SCOTTSDALE

Unified School District

SITE DESIGN REVISIONS & REVIEW

January 11th, 2020

DROP OFF & PARENT PLAZA

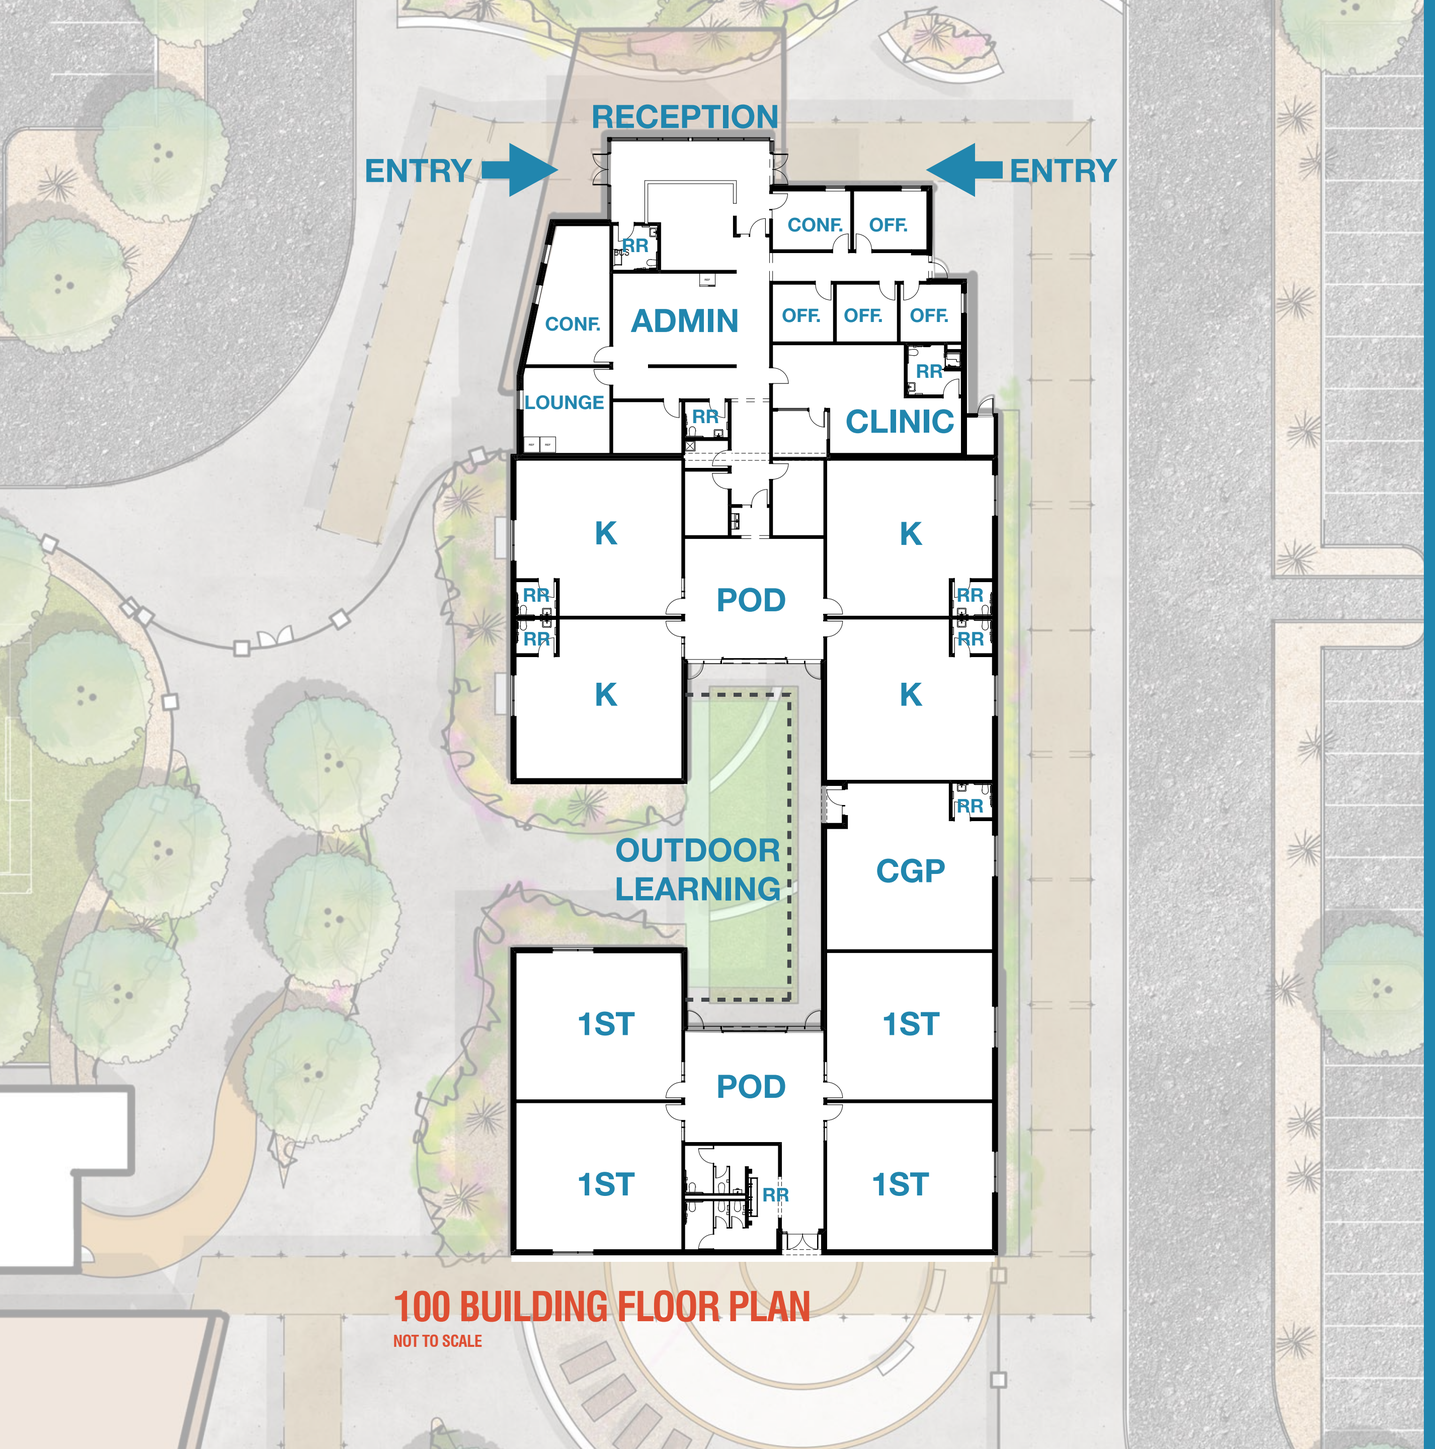
REORIENTATION OF SHADE STRUCTURE TO PROVIDE SHADE AT PICK-UP TIMEFRAME

100 BUILDING FLOOR PLAN

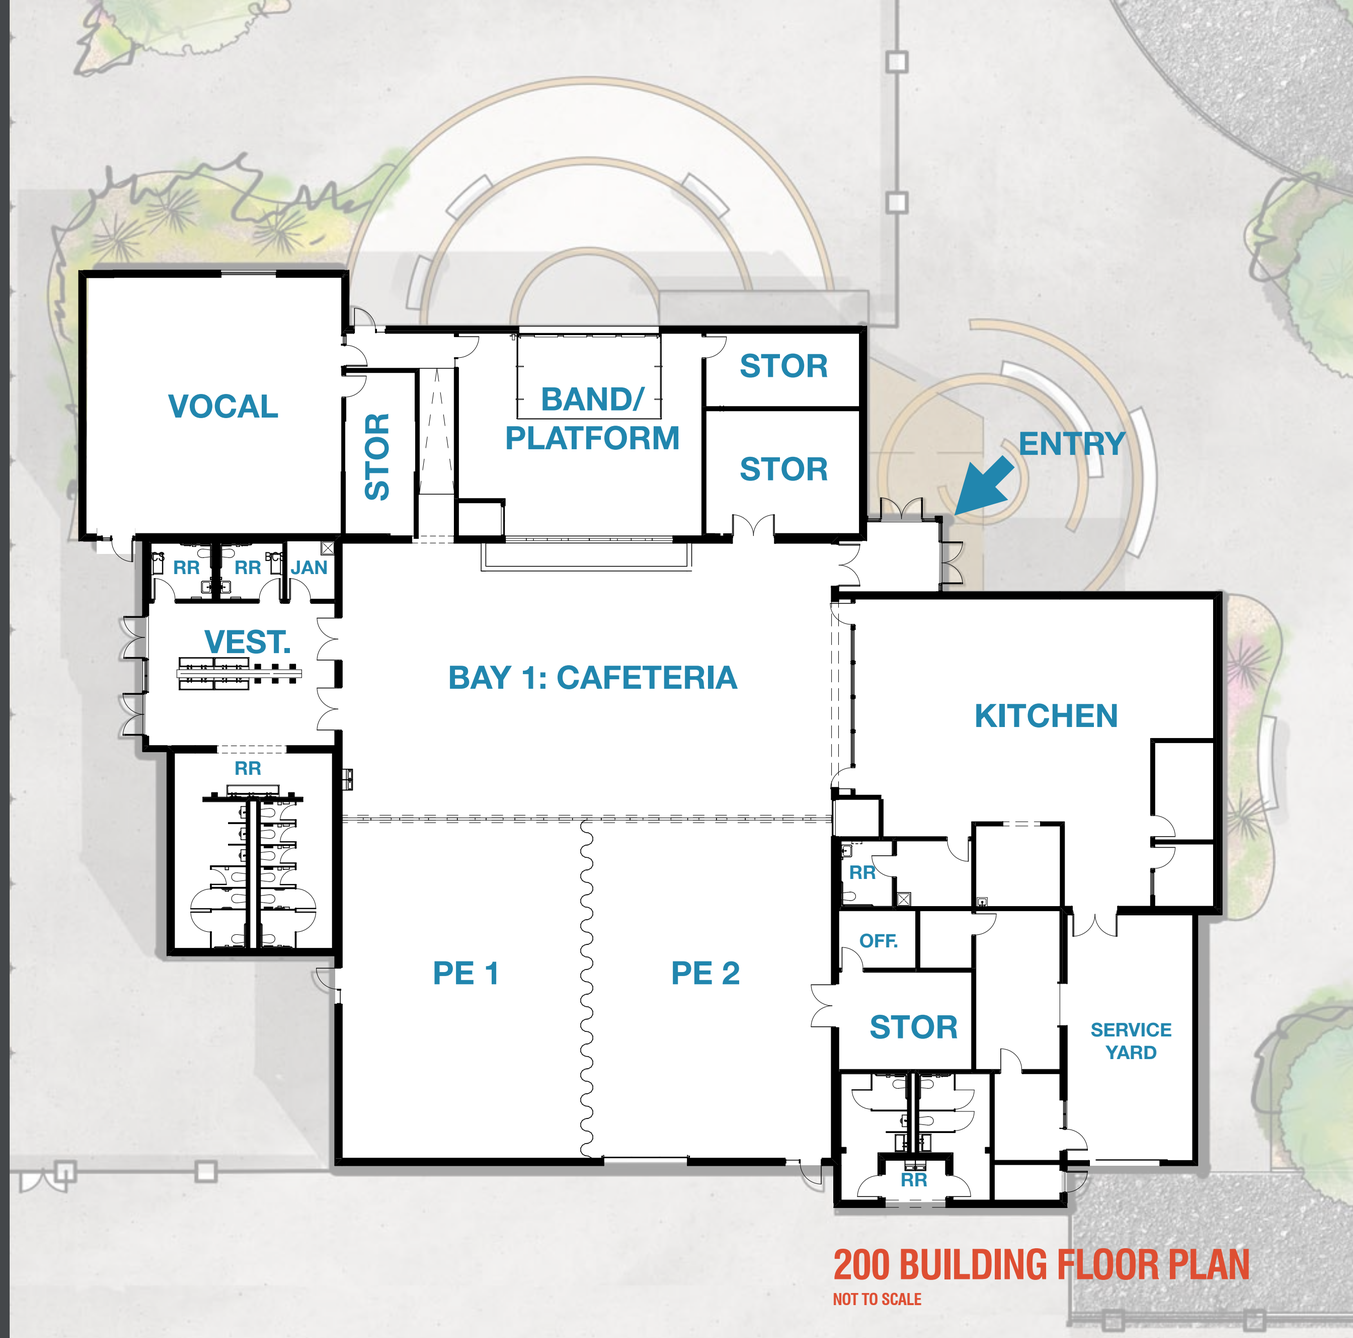
- Reorientation of western canopy for both drop-off and pick-up. Shade study will be performed to maximize shade efficiency. Surrounding site design reflects the queueing needs of the staff/ students during pick-up.
- Plan reflects additional revisions to the administration areas for functionality, efficiency, etc.
- Extent of canopy adjusted to connect pods by covered walkway.

PARTIAL 200 BUILDING FLOOR PLAN

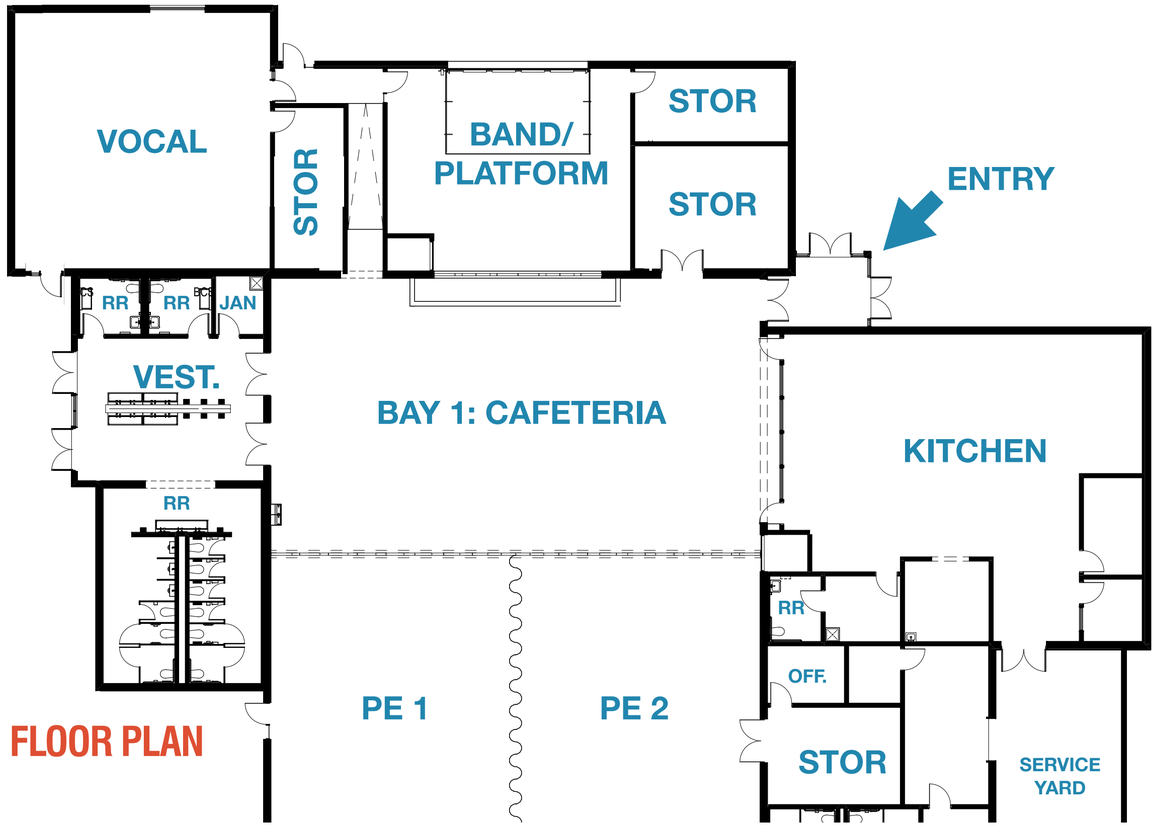
- **Current utilization of the Vocal, Band & Strings program will be confirmed.** A design that reflects current usage and future projected usage will be explored. Providing ease of future expansion will be incorporated to the greatest extent possible.

- Per comments received, Vocal is utilized a great deal more than Band, so Band has been located on the platform.
- Small revisions to circulation to ensure convenient ADA access is provided to both the Vocal and Band rooms.

Figure 4: On-Site Storage Length Available with Dual-Lane Queuing

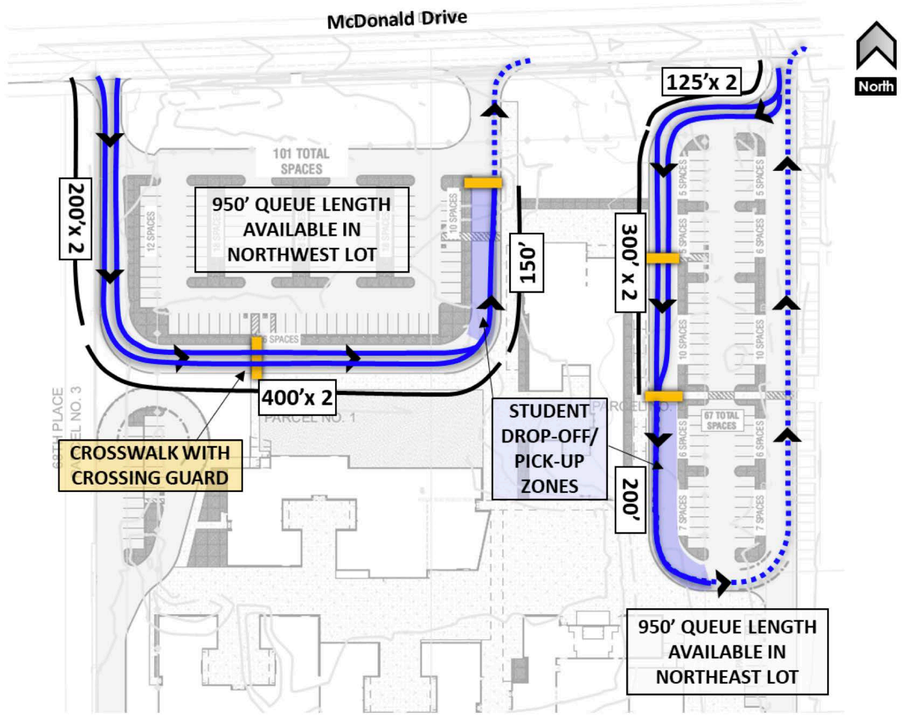
- A **full traffic impact analysis will be performed** to identify all available strategies to limit traffic disturbance in the neighborhood while providing a safe arrival and departure sequence for all pedestrians and vehicles on campus.

- Double lane of queueing to maximize amount of traffic able to get on to campus and off of McDonald Drive
- Compression to single lane for drop-off and pick-up to ensure safest arrival/departure possible.
- Limits "duty" requirements as much as possible.
